SUBJECT: Transmittal of Revised Responses to AP1000 DSER Open Items

**AP1000 Design Certification Review
Draft Safety Evaluation Report Open Item Non-Proprietary Responses**

DSER Open Item Number: 19.1.10.1-5 (Response Revision 1)

Figure A5.3-11

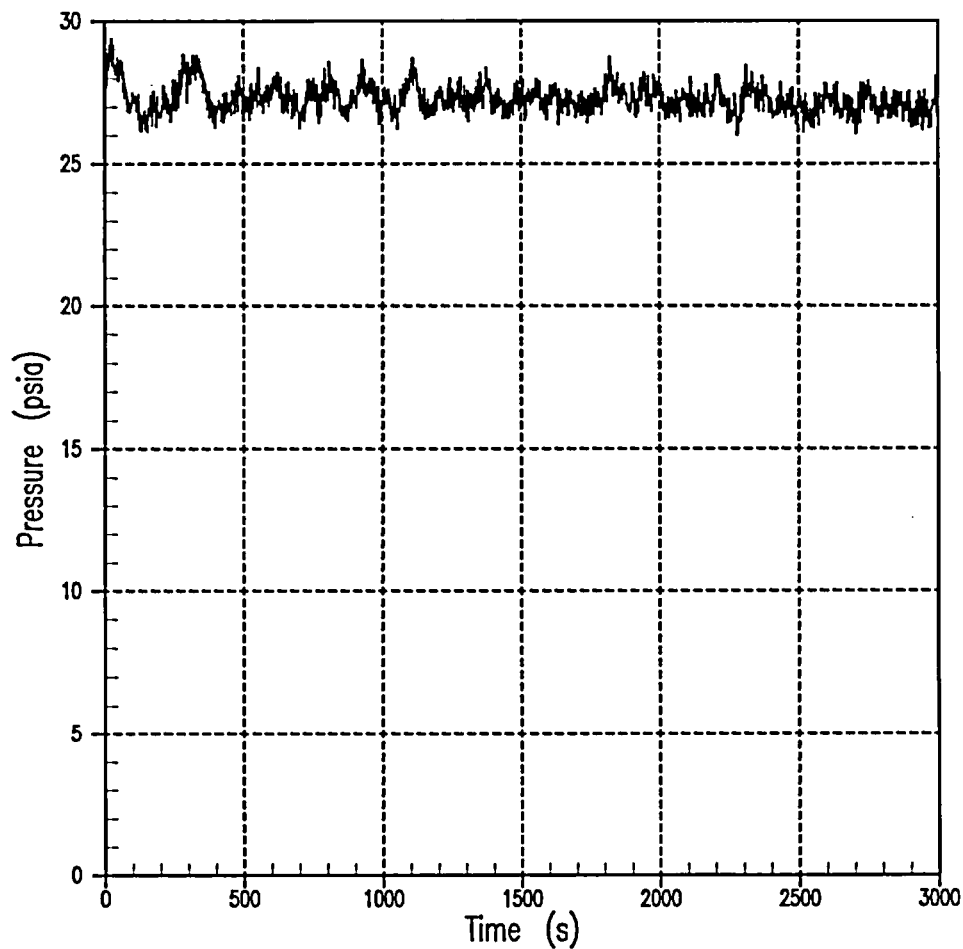
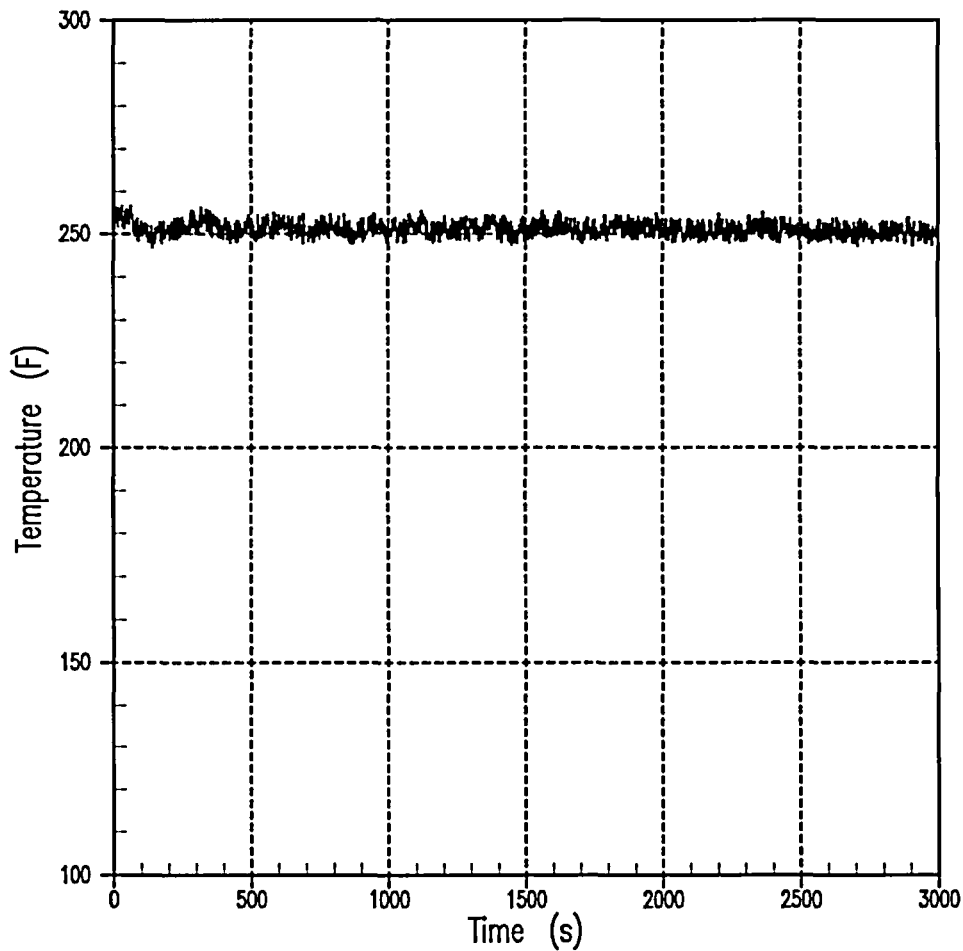
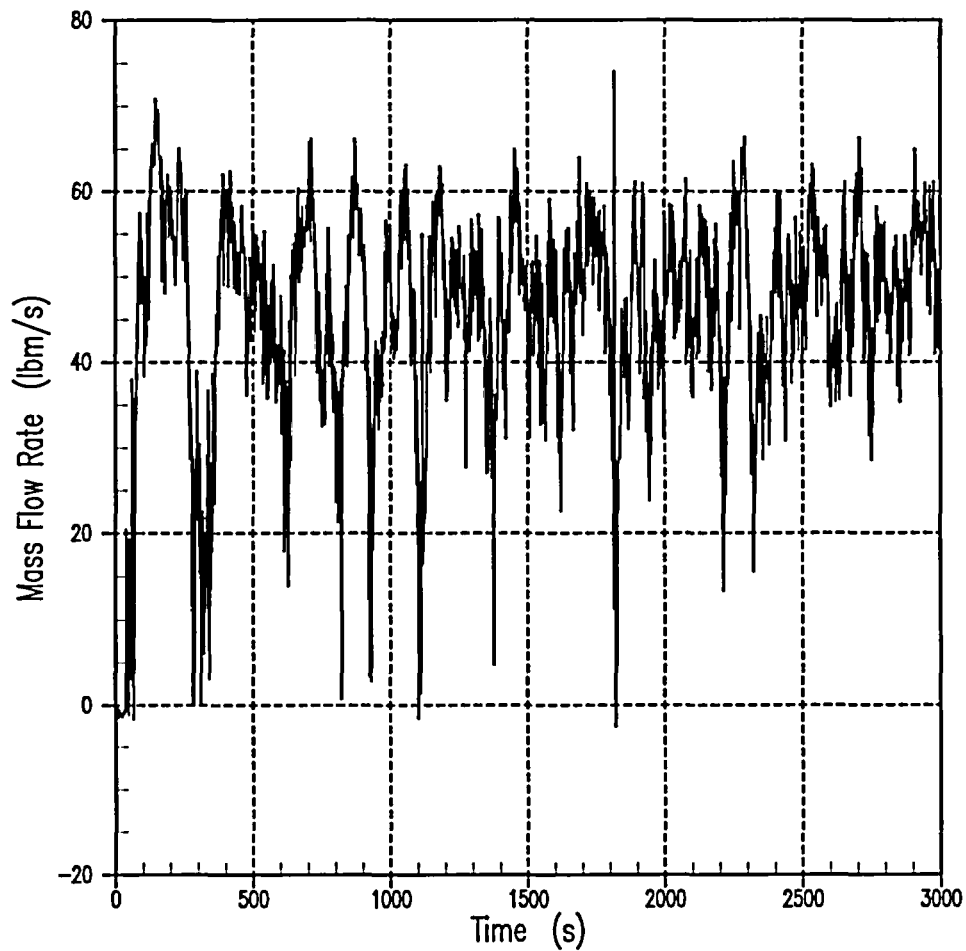
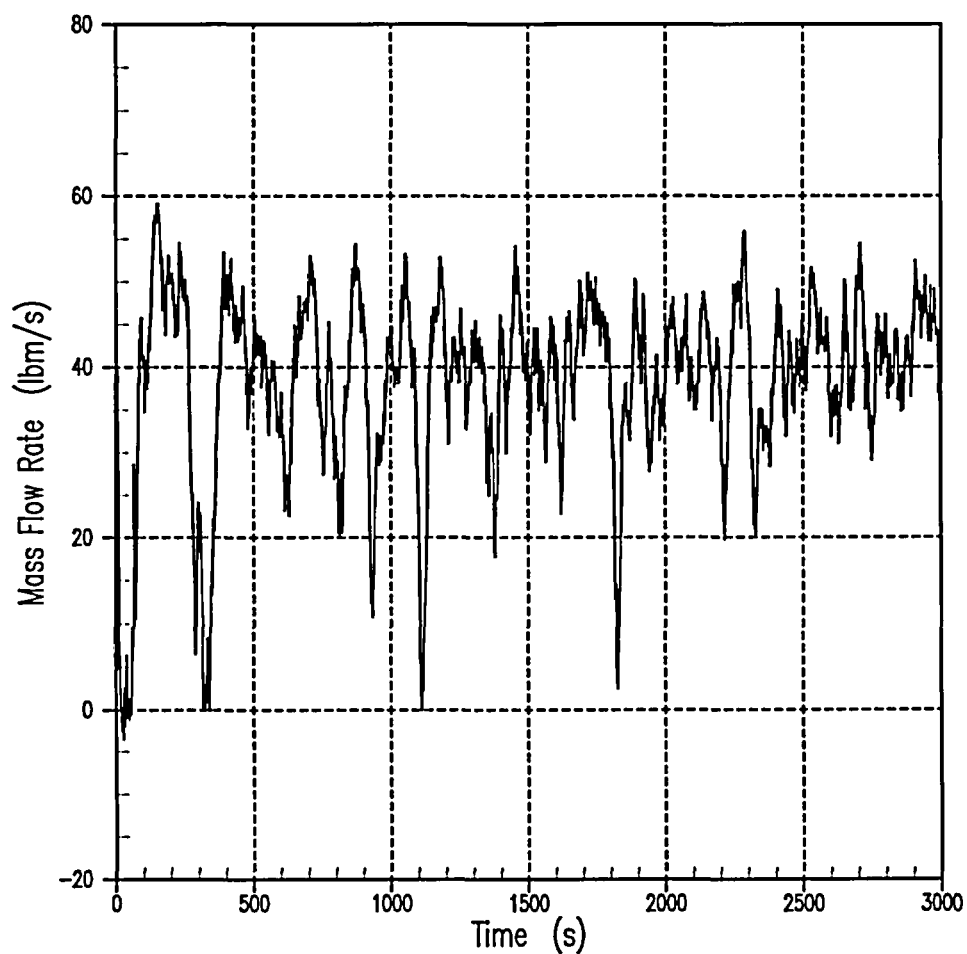
This issue remains open. In the revised response to RAI 720.013, Westinghouse performed long term cooling analyses for bounding conditions in the PRA. (Case F DEDVI, 1 CMT, 1 recirc line, 3/4 ADS4 and CI) and (Case G DEDVI, 1 CMT, 1 recirc line, 4/4 ADS4 and CI failure). The WCOBRA/TRAC code was used for LTC calculations with input conditions derived from MAAP4 analyses. As discussed in the DSER the staff has not reviewed MAAP4 except for its use in screening studies. These are analyses using minimum equipment sets as discussed in the DSER. The staff believes that only a methodology the staff has reviewed should be utilized. In addition, as a result of staff and ACRS questions, the WCOBRA/TRAC long term cooling model has been changed. The staff believes that the revised model should be used in these bounding calculations.

- (a) The long term cooling success criteria analysis case and the thermal hydraulic uncertainty cases F and G have now been performed using the revised WCOBRA/TRAC model and using input conditions from WGOETHIC. The revised cases replace the previous cases as shown below in the revision to PRA Appendix A.

momentarily, faster depressurization occurs at about 2.05 hours into the transient (Figure A5.3-11). Consequently, the IRWST injection is increased even further, and as a result, the levels in the downcomer (Figure A5.3-1), the reactor core (Figure A5.3-2), and the upper plenum (Figure A5.3-8) are also increased. The effect of this injection flow increase can also be seen on Figure A5.3-4, which shows a sharp void fraction decrease in the upper half of the fuel region adequate to maintain acceptable core cooling.

The available three out of four ADS Stage 4 valves provide enough venting capacity to assure adequate depressurization and successful performance of the passive safety systems (Figures A5.3-9 and A5.3-10). The fuel remains covered throughout the transient and adequate core cooling is provided to remove the decay heat. The hot rod cladding temperature at the top of the core is about 20°F above saturation (Figure A5.3-12) and is steadily decreasing exhibits no excursions.
